ADDENDUM NO. 01

SYRACUSE HANCOCK INTERNATIONAL AIRPORT

RECONFIGURE TAXIWAYS C, F, B, E, AND G

June 6, 2018

SYRACUSE REGIONAL AIRPORT AUTHORITY			
CITY OF SYRACUSE, STATE OF NEW YORK			
RECONFIGURE TAXIWAYS C, F, B, G, AND E			
EROSION & SEDIMENT CONTROL PLAN (SHEET 1 OF 4)			
SCALE:	1"=50'	DESIGN:	JPM
DRAWN:	JPM	PROJECT:	18180.04
CHECKED:	WEV	DATE:	MAY 2018
			EC-01
			34 OF 55

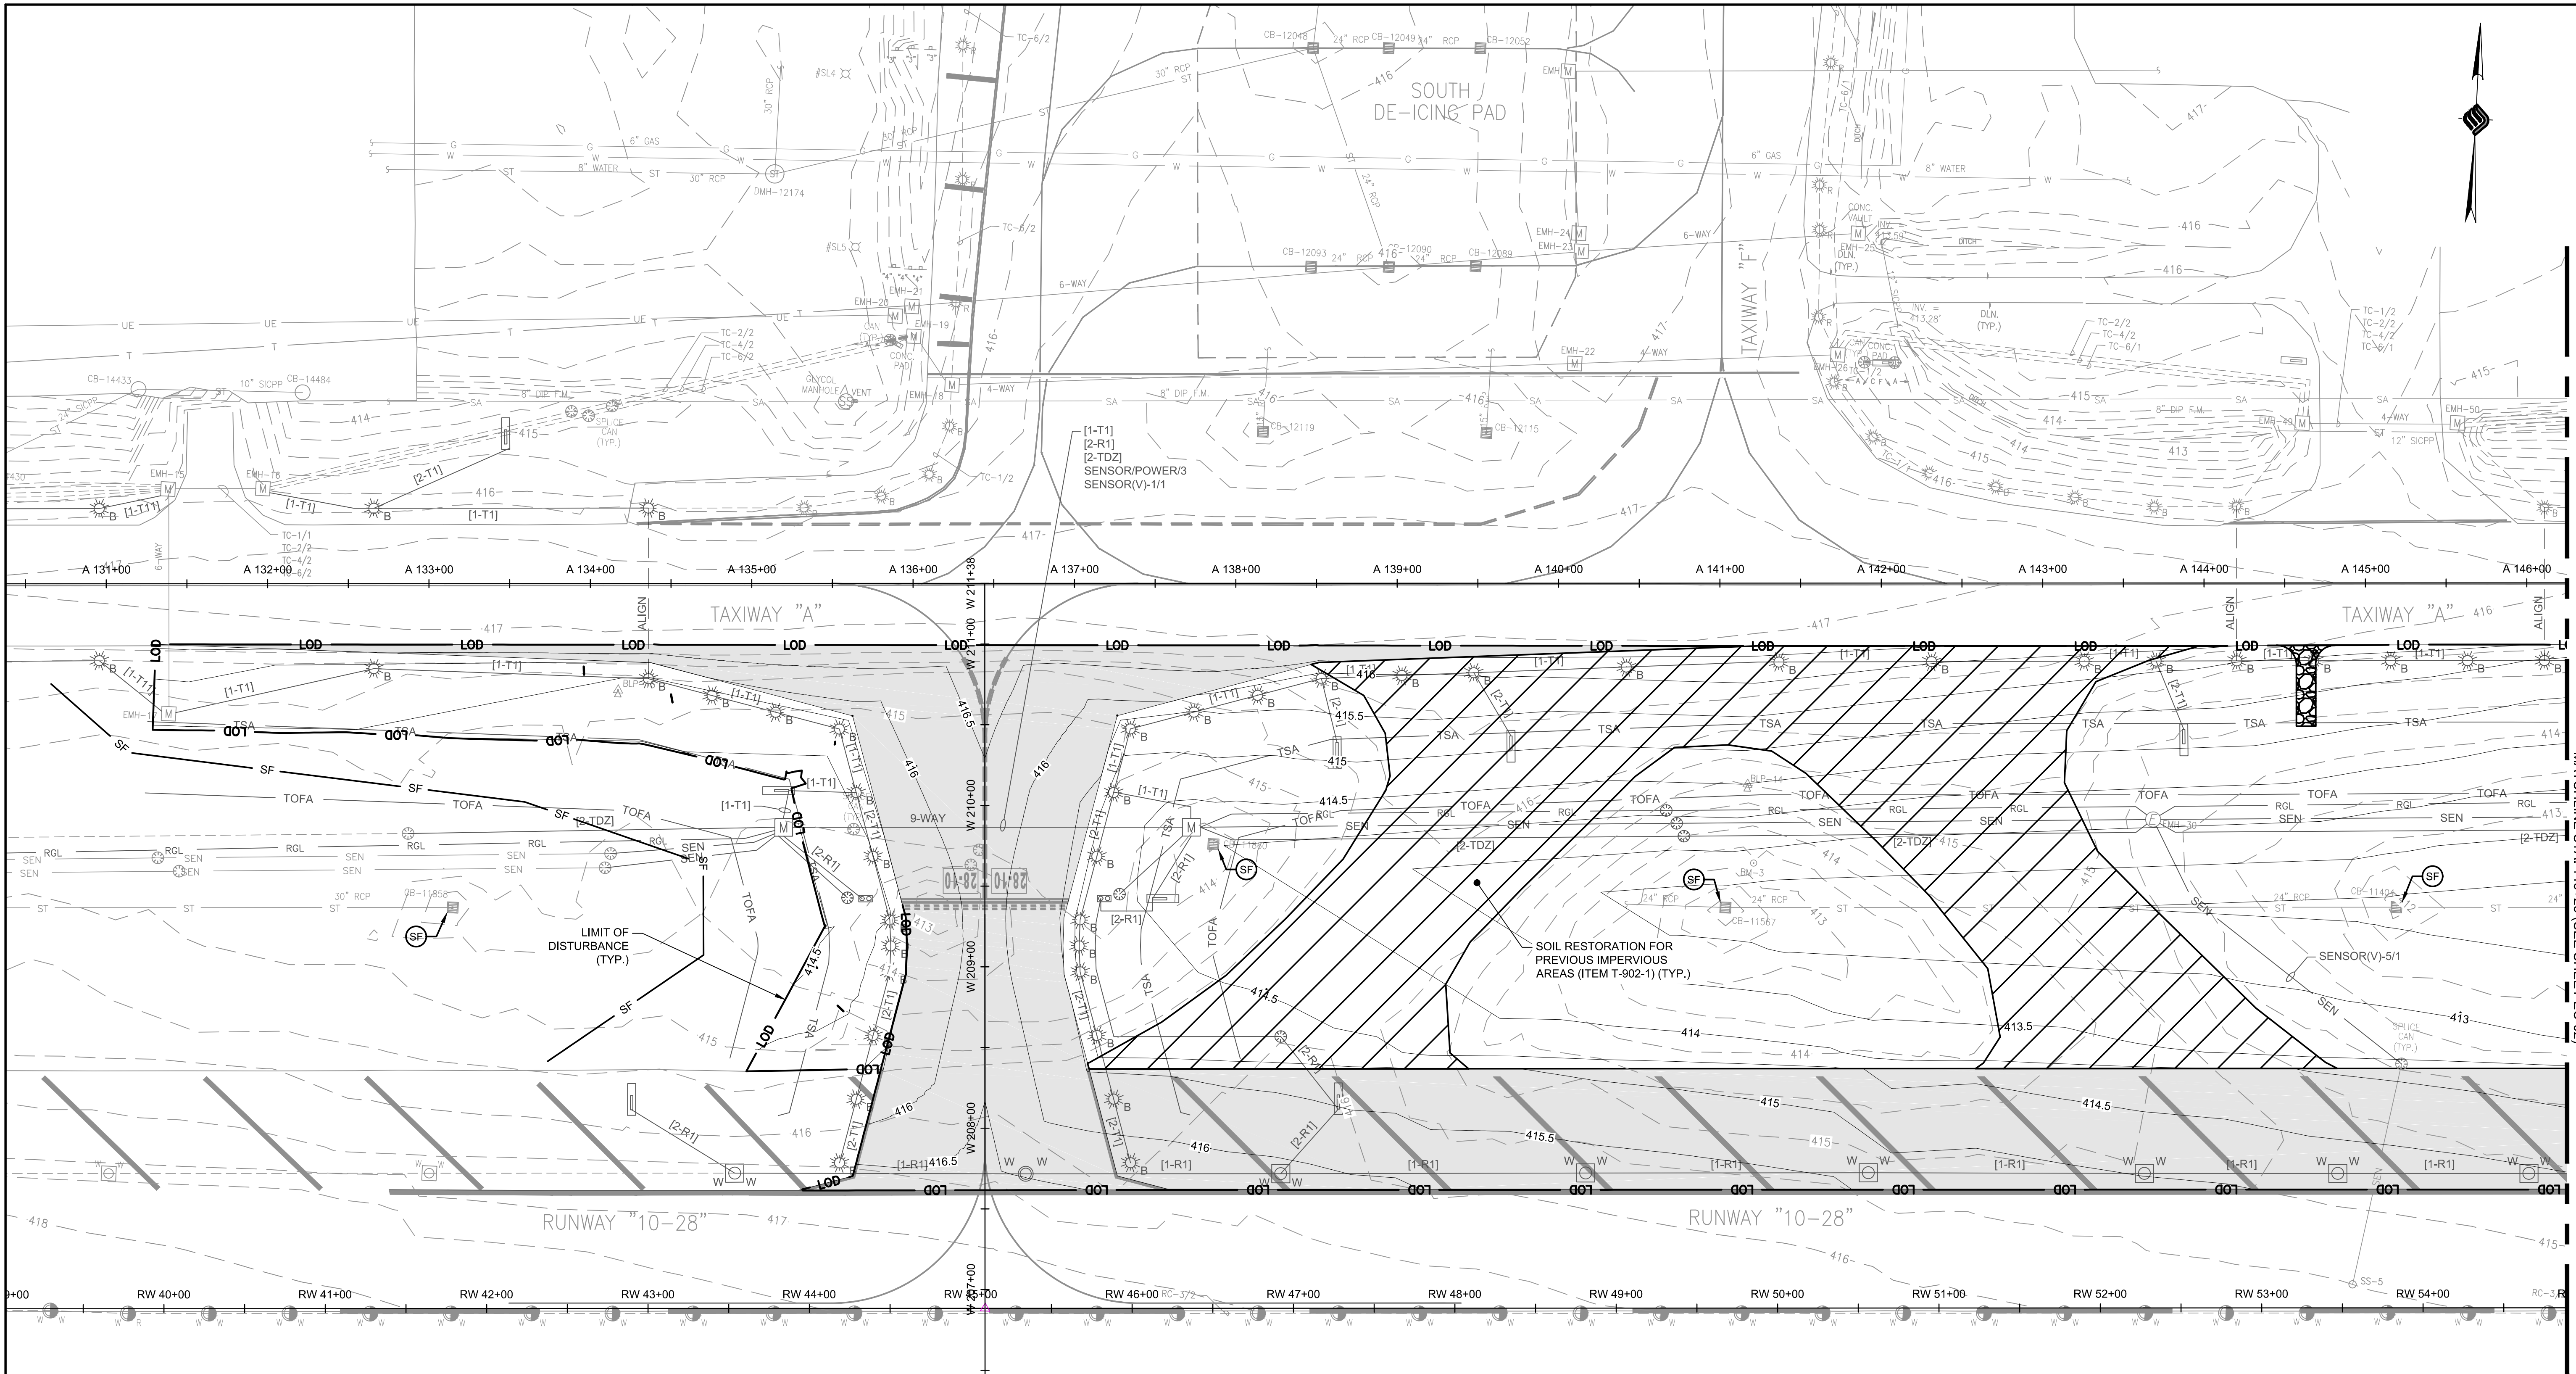
- i. GR-04 GRADING & DRAINAGE PLAN (SHEET 4 OF 4)
 - i. Added existing contour labels.
 - j. EC-01 EROSION & SEDIMENT CONTROL PLAN (SHEET 1 OF 4)
 - i. Added existing contour labels.

**SYRACUSE REGIONAL AIRPORT AUTHORITY
 CITY OF SYRACUSE, STATE OF NEW YORK
 RECONFIGURE TAXIWAYS C, F, B, G,
 AND E
 EROSION & SEDIMENT CONTROL PLAN
 (SHEET 2 OF 4)**

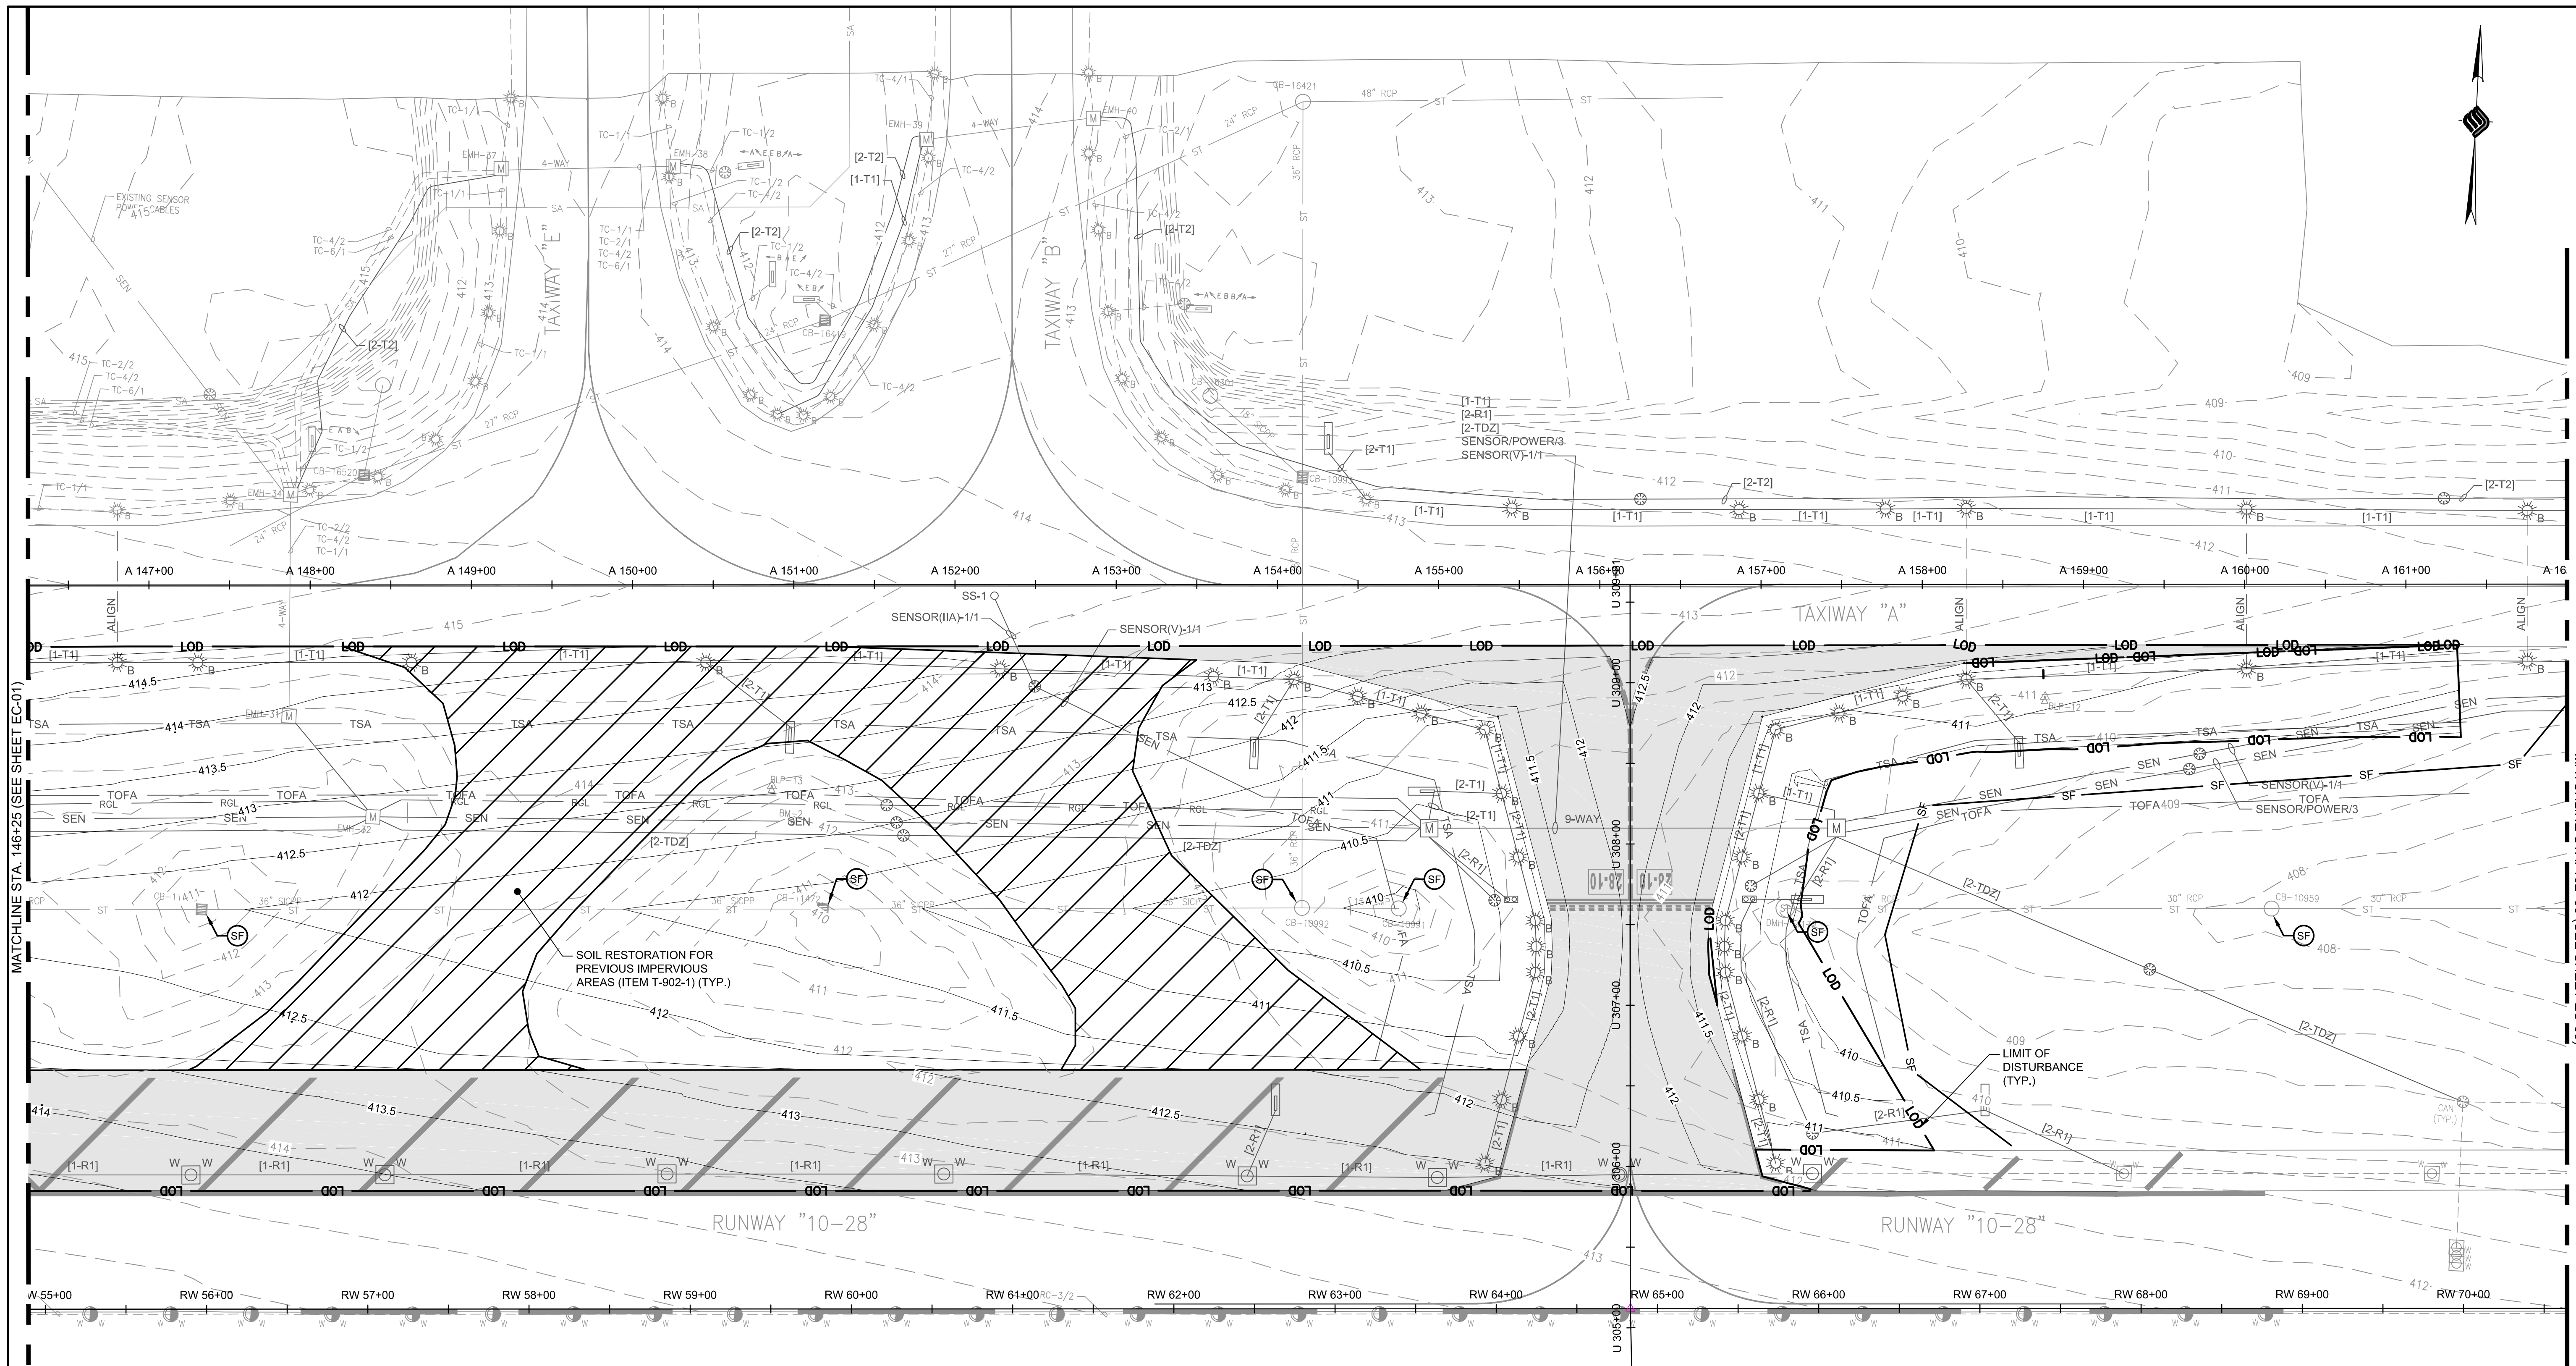
- i. Added existing contour labels.
 - l. EC-03 EROSION & SEDIMENT CONTROL PLAN (SHEET 3 OF 4)
 - i. Added existing contour labels.
 - m. EC-04 EROSION & SEDIMENT CONTROL PLAN (SHEET 4 OF 4)
 - i. Added existing contour labels.
- 2. Add the following sheets (Attached):
 - a. CS-04 CONSTRUCTION SAFETY & PHASING PLAN (SHEET 4 OF 4)
 - i. Added new 12-hr duration work area to install/remove temporary markings, interim retroreflective markers, low-profile barricades, lighted X's, and make modifications to airfield lighting circuits for the Phase 1 Runway 10-28 closure.
